23RD MAY 1884, No. 1297 W., PUBLIC WORKS.

Christ Church, Cuddapah

Stating that it is not possible to make any grant of funds for the erection of a belfry for —, and that the question as to departure from the original design for the church will be remitted to Mr. Chisholm on his return from leave.

PLAN OF CUDDAPAH CHURC

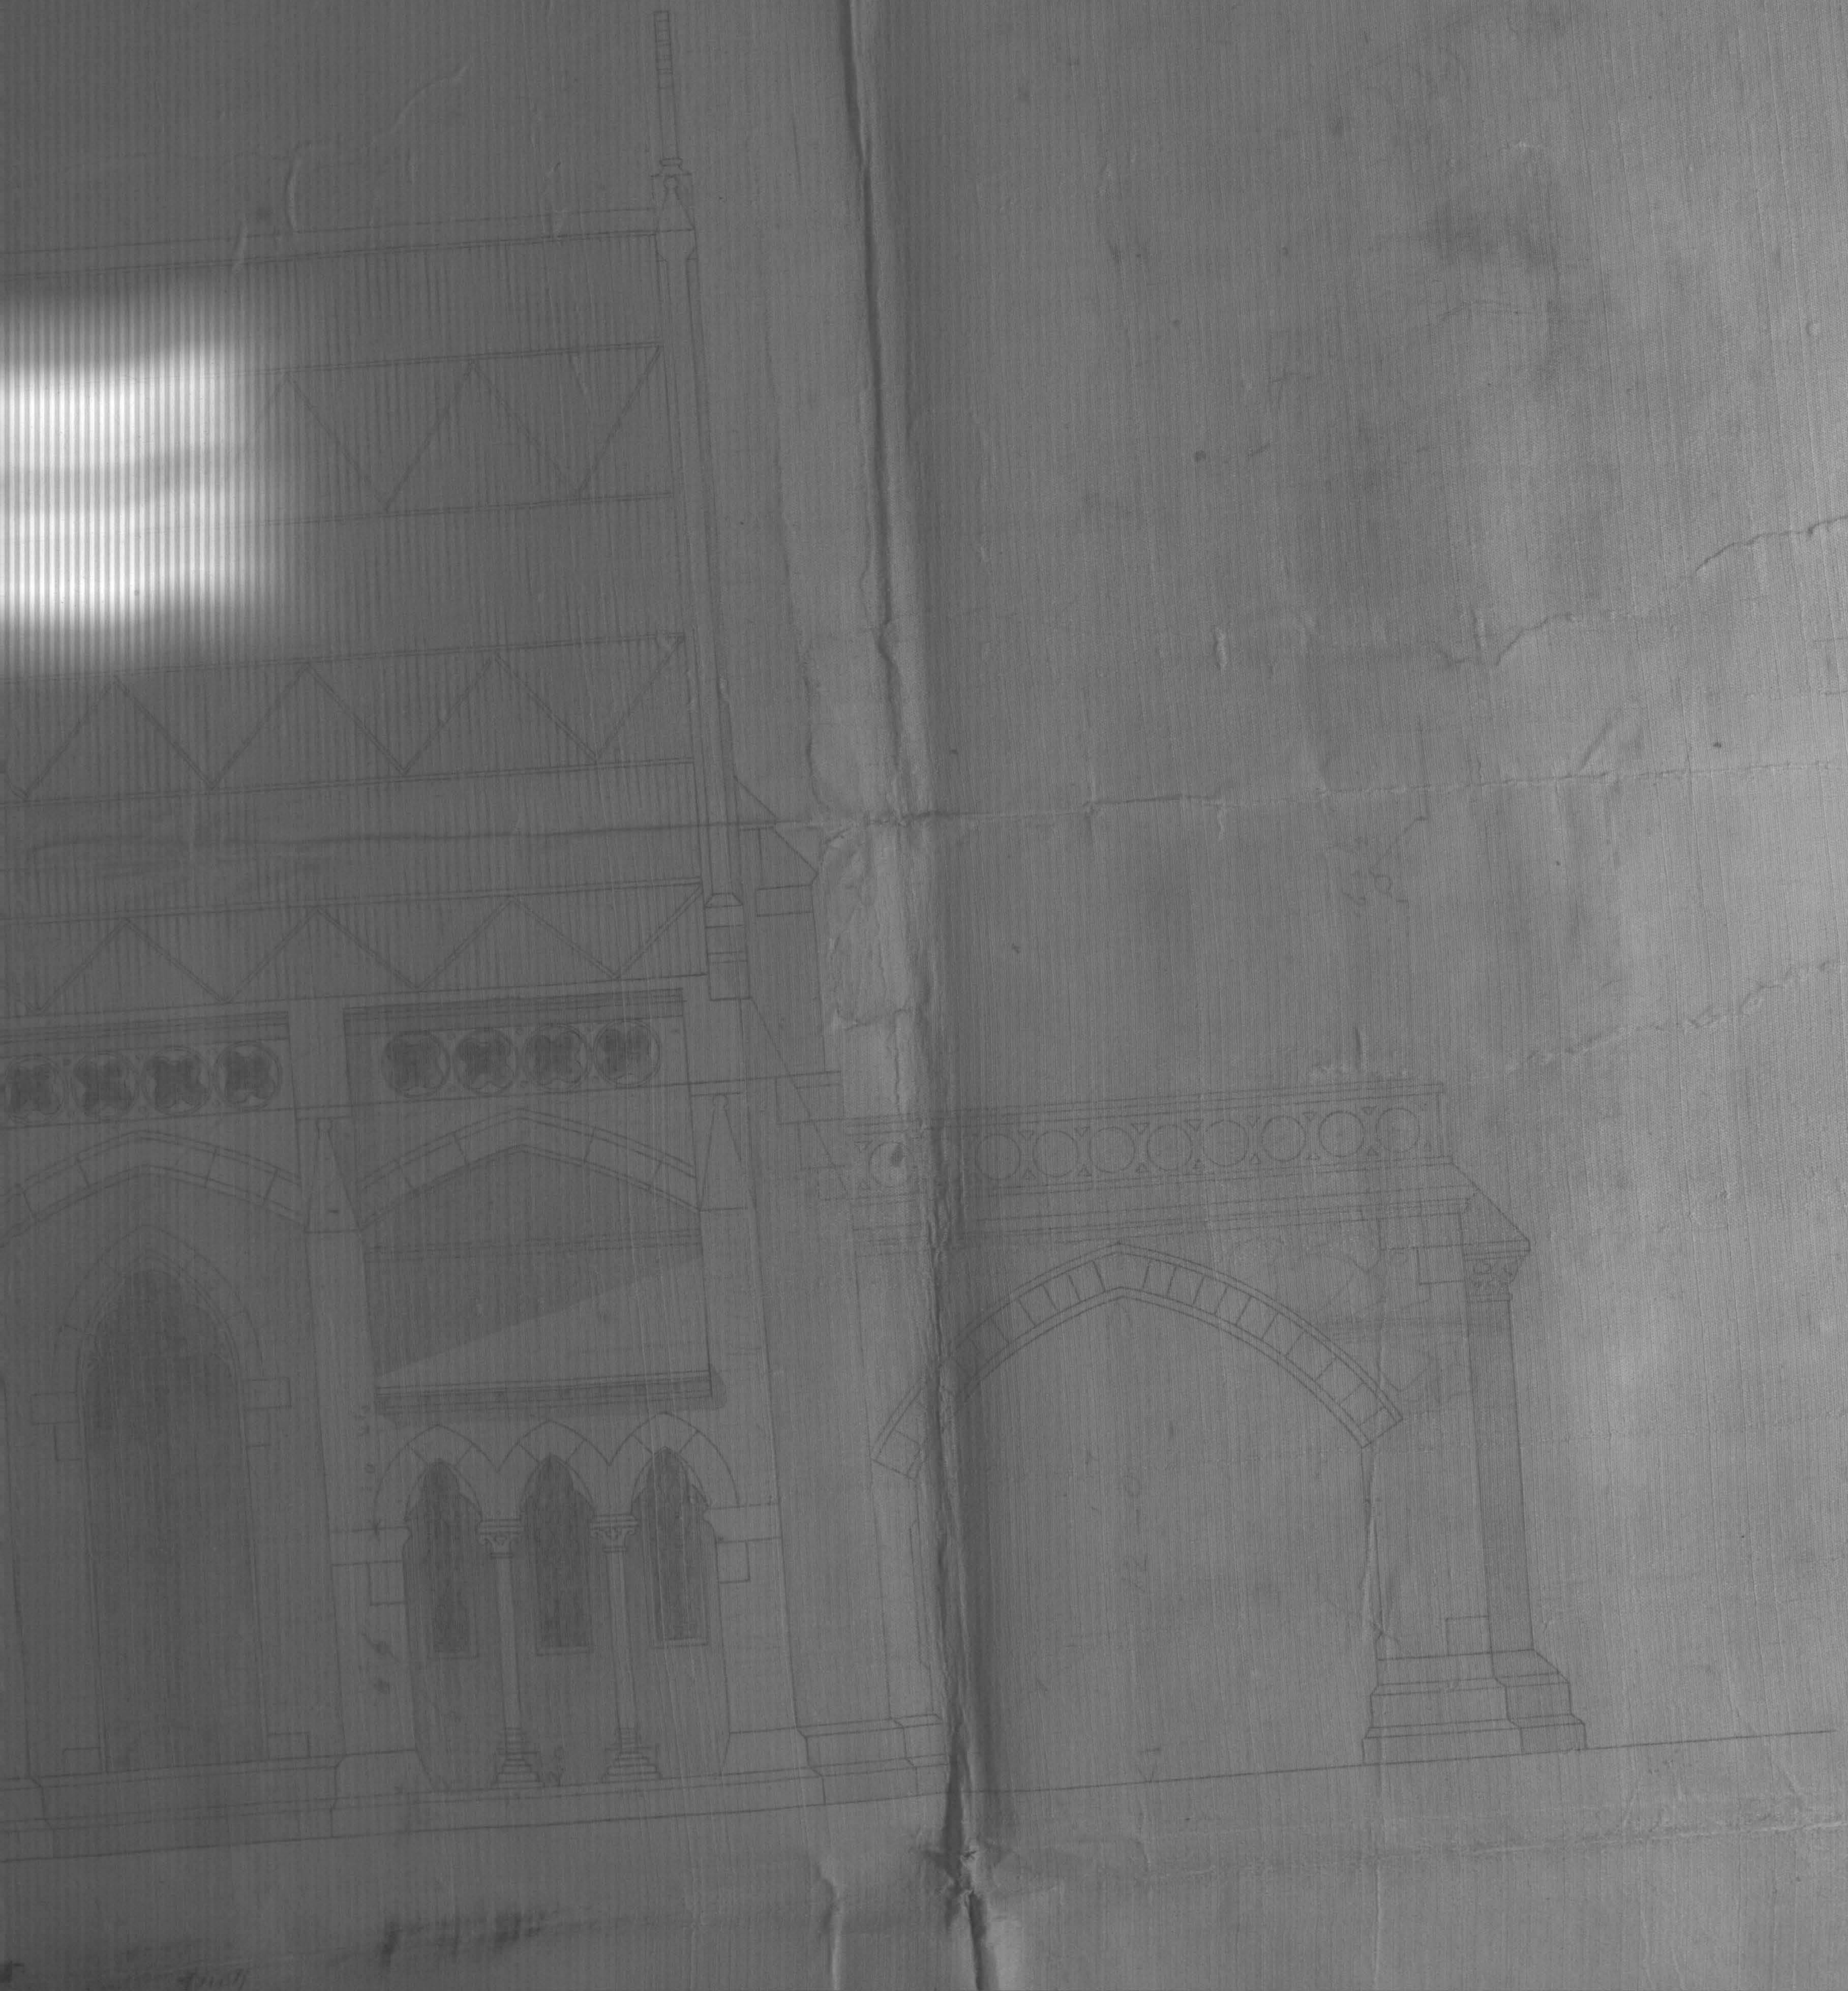
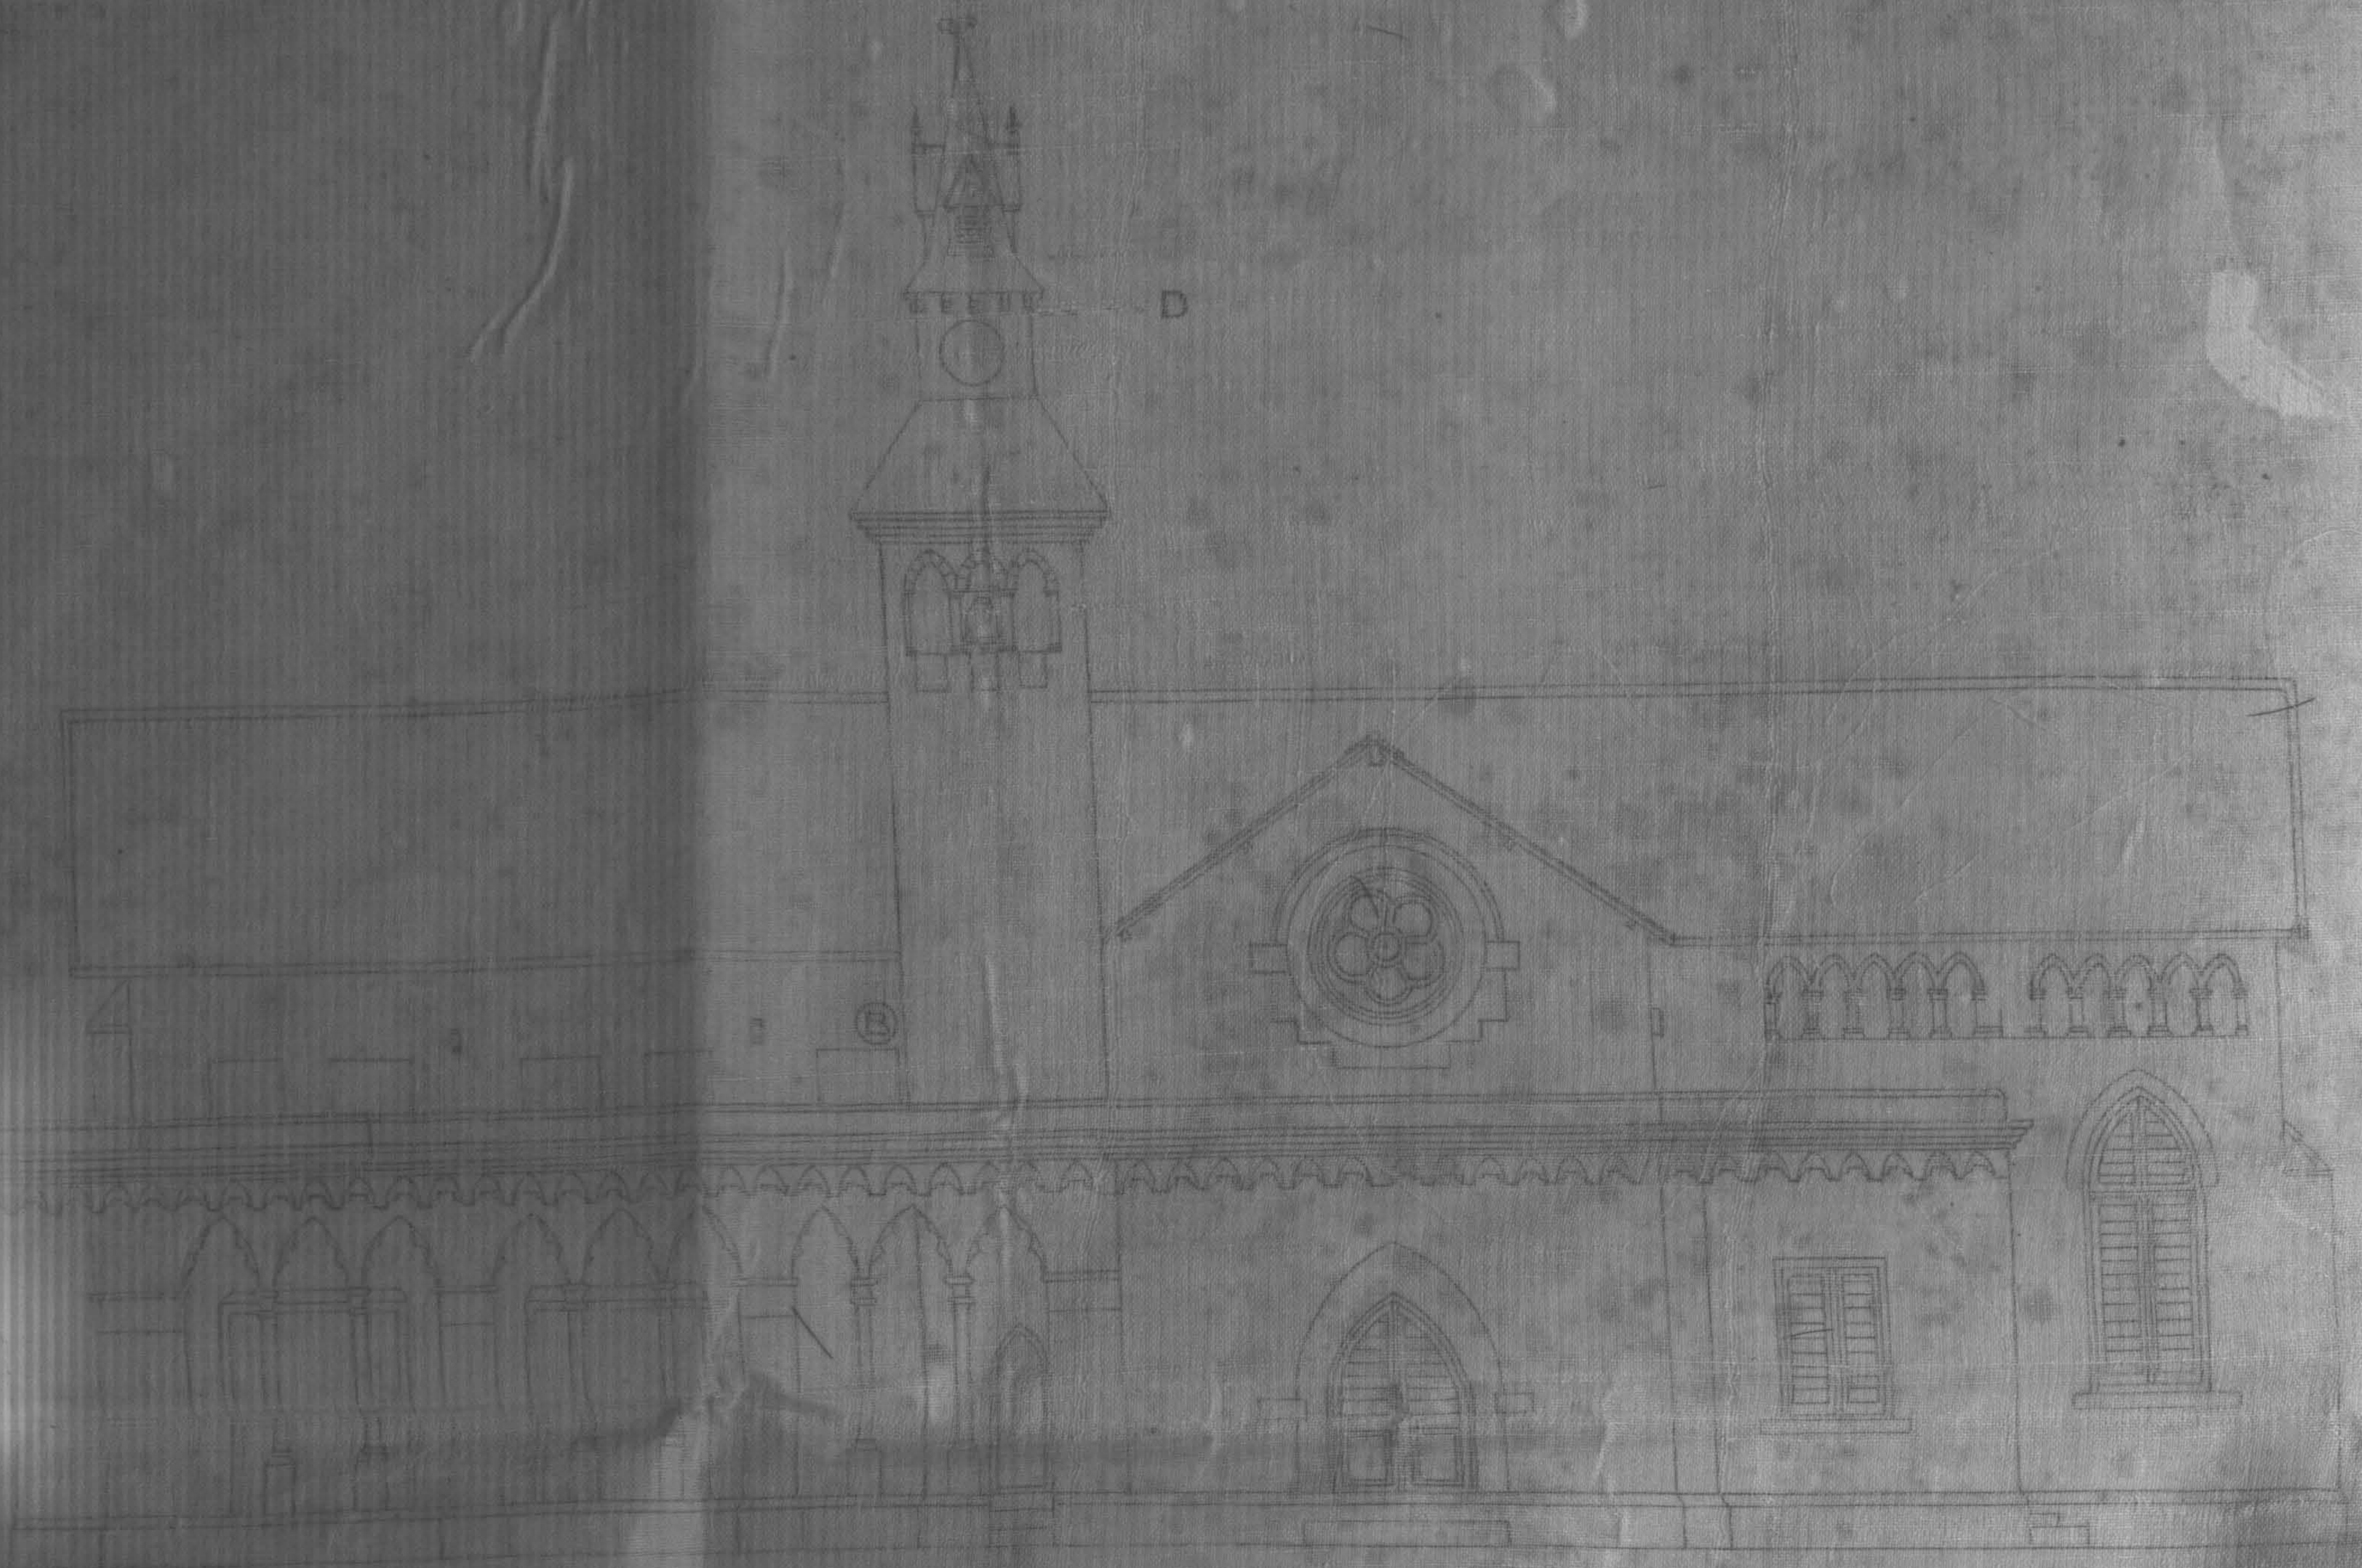
The belfry will occupy a space in the Corner of the South verandah. It may be built quite free of the building in that corner if thought desirable and not as shewn in the plan. The turret will at bottom be 7 feet square outside and 5 feet diameter inside, Containing a circular spiral Stairs formed of Stone slabs about 8" thick. 28 feet over basement level the inside of the turret will become 5 feet square and then the first stone roof will taper upwards and thus become about 4 feet square over which the wooden top, to be supplied from Madras, will be firmly secured in any manner the Executive Engineer may determine. where the main roof joins the turret Lead flashing should be used. The materials are left to the Executive Engineer. Cuddapah. to decide upon as well as quality of work &c.

In compliance with Public Works G. O. No. 1921 W dated 9th July 1883, I have the honor to enclose a plan and Estimate, the latter amounting to Rs 718, for erecting a Belfry to the Cuddapah Church. The Elevations sent by the Executive Engr. Cuddapah Division shew that the Church has not been erected in accordance with the design originally supplied by Mr Chisholm. I enclose one plan of Mr Chisholm's design for comparison, and shall be obliged by its being returned when done with. Apparently from the elevations supplied the structure now presents a rather incongruous appearance. I have found it difficult to design a suitable belfry to accord in any way with the structure as erected. I see no objection to the belfry (which will be very light) being erected in the corner of the south Verandah as shewn on the plan. The work there is very massive and will, no doubt easily bear the comparatively small weight of the turret. I propose utilizing a top now lying at the School of Arts which was intended for a Clock Turret in Madras now abandoned. I have written no detailed specification as this can best be done by the Executive Engineer Cuddapah Division. But the specification describes in a suggestive way what the design intends to accomplish.

A DOOR SIMILAR TO Ⓐ ON WEST SIDE OF TURRET.
LEADING TO TOP OF VERANDAH AT Ⓑ
